## SAFETY ADVISORY # 16-247

### Sprinter 353DEN Haier TV

Fig. 2

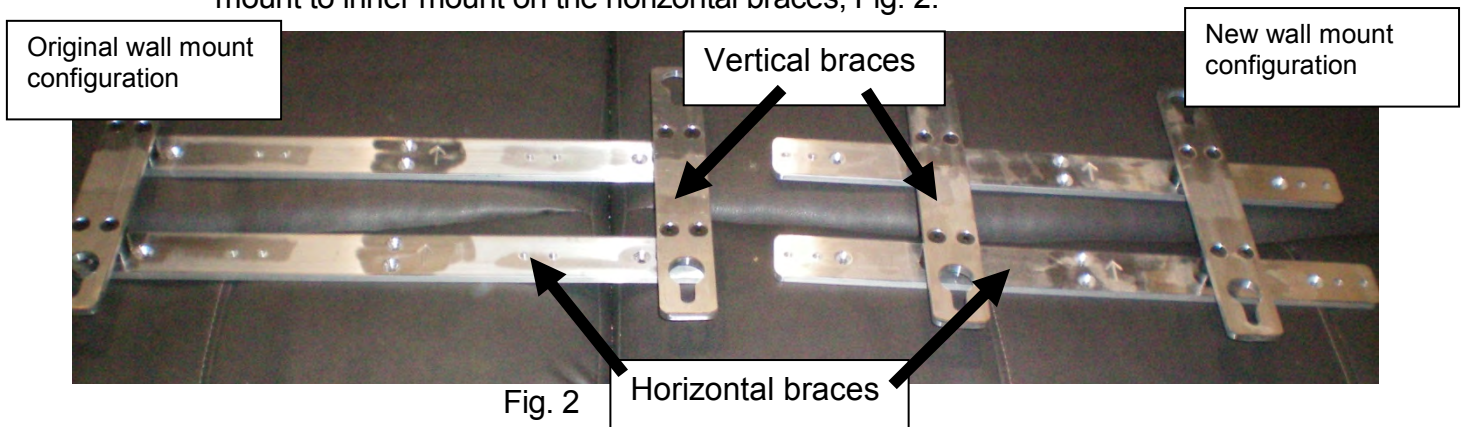
**Step 2** Remove wall bracket. Reconfigure wall bracket by moving both vertical braces from outer mount to inner mount on the horizontal braces, Fig. 2.

Fig. 3

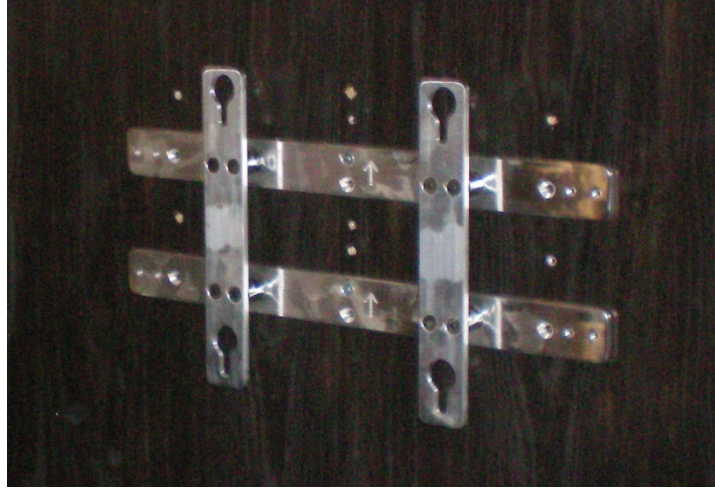
From the bottom of the overhead cabinet, measure down 17" for new mounting location of the bracket, centered and level, should be 2" below the original installation holes, to re-install wall bracket. Install wall bracket in new position, Fig. 3. Putty holes.

Fig. 4

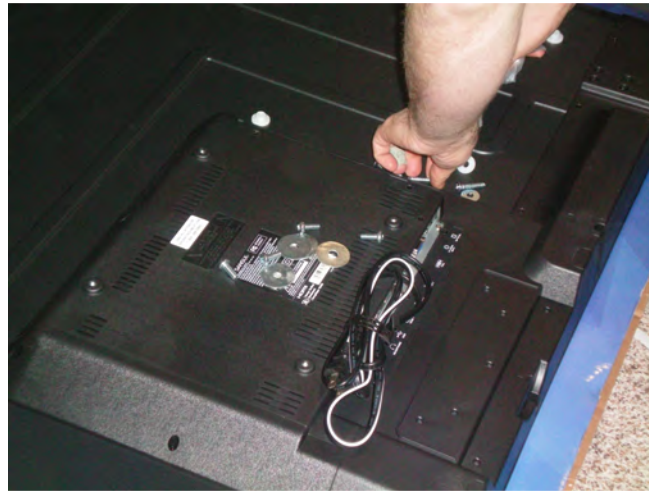
Re-install washers and spacers with new screws, KRV # - 310820 which will be supplied with the replacement TV, onto back of replacement TV. Note: Do not over-tighten screws, Fig. 4.

Fig. 5

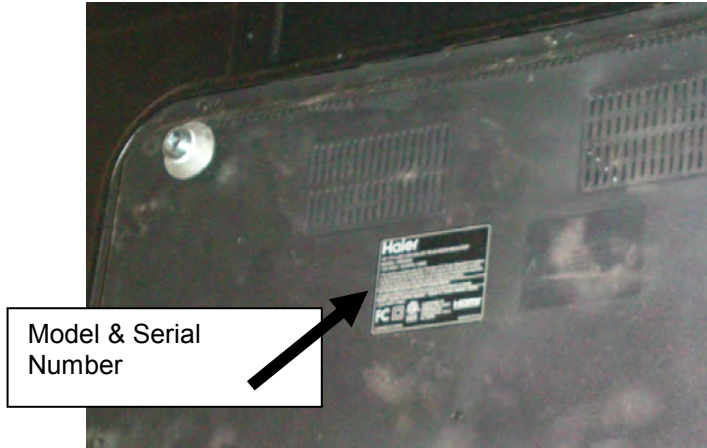
**US & Canada** – No part return is required. 1) Attach a picture to the claim of model number and serial number sticker found on back of Haier TV, Fig. 5 Information in picture must be clear and legible. 2) Render the TV incapable of being wall mounted again by using a 1/4" drill bit to drill in 3/8" deep into each mounting lug of the Haier TV., Fig. 6.
